INDESIT company

WITXL129EU

F050760

1140960 Exploded views

n4008f00: Thermic link wire removed on three-phase motor

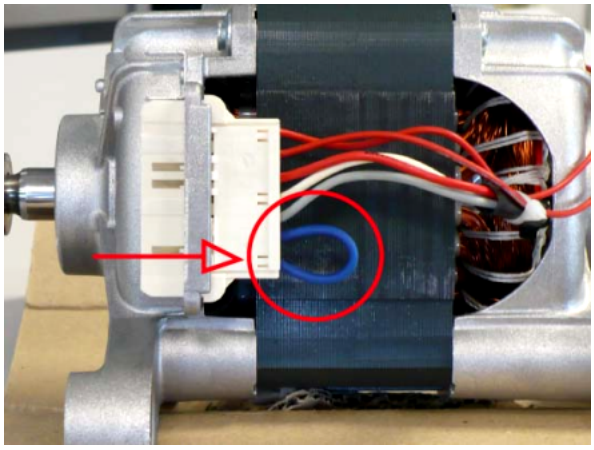
Attention!

When you assist the premodification models using the new motor code you MUST use the thermic link wire code C00265838.

The spare part warehouses will manage the premodification motor until the end of the stock, after they will be replaced with new ones and thermic link wire.

TRIPHASE P32 46 L TOP LOADING
C00265832 new motor without thermic link wire - C00262375 premodification motor with thermic link wire

In the attached image you can see the fixing of thermic link wire in the motor therminal box.
